Product Change Notification: BLAS-13MWGE002

CCB 7222 Final Notice: Qualification of MMT as an additional assembly site for MCP6V03T-E/MNY, MCP6232T-E/MNY, MCP6V06T-E/MNY, MCP6V08T-E/MNY, MCP6V01T-E/MNY, MCP6052T-E/MNY, MCP6062T-E/MNY, MCP6402T-E/MNY, MCP6072T-E/MNY, MCP651T-E/MNY, MCP6051T-E/MNY, MCP6071T-E/MNY, MCP6061T-E/MNY, MCP661T-E/MNY, MCP6442T-E/MNY, MCP621T-E/MNY, MCP631T-E/MNY, MCP6V28T-E/MNY, MCP6V26T-E/MNY, MCP16251T-I/MNY, MCP16252T-I/MNY catalog part numbers (CPN) available in 8L TDFN (2x3x0.8mm) package.

PCN Status: Final Notification

PCN Type: Manufacturing Change

LEAD FRAME COMPARISON

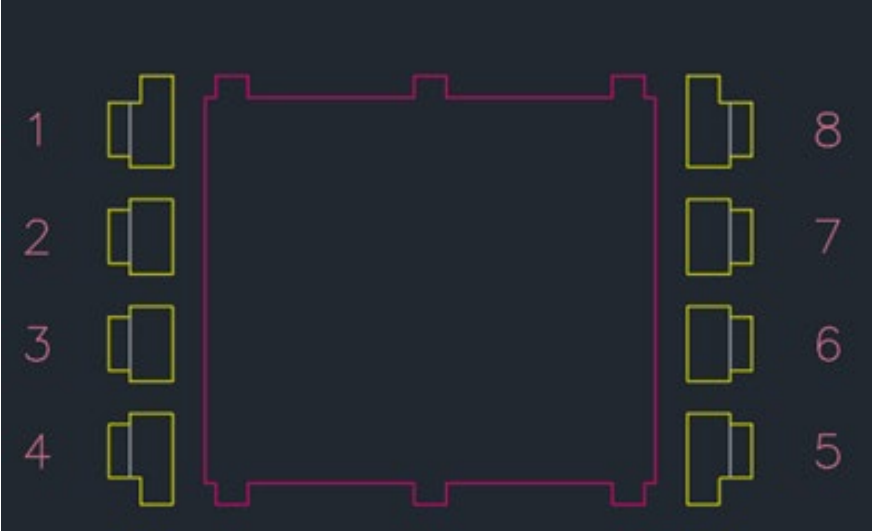
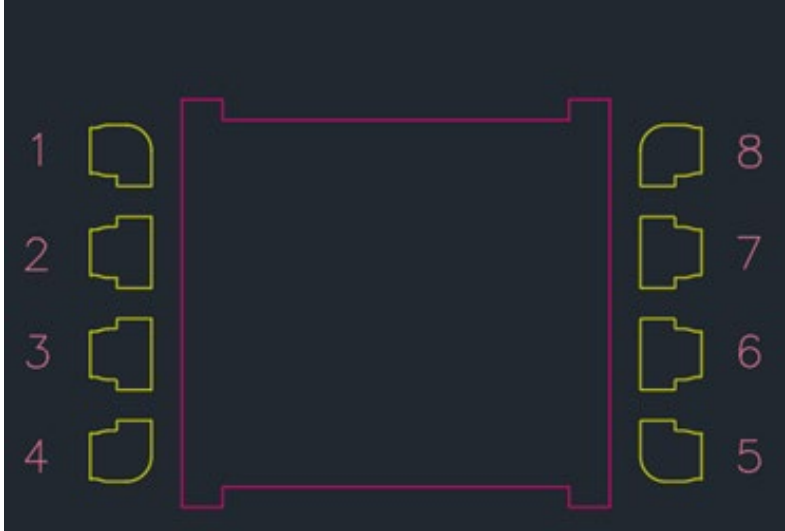
Lead-Frame Material	C194																
Lead-Frame Paddle Size	83x71 mils																
Lead-Frame Lead-lock	Yes																
DAP Surface Prep	NiPdAu																
Lead-Frame Material	A194																
Lead-Frame Paddle Size	83x71 mils																
Lead-Frame Lead-lock	No																
DAP Surface Prep	NiPdAu

Note * C194, A194 or CDA194 Lead frame material are the same, it is just a MCHP internal labelling difference
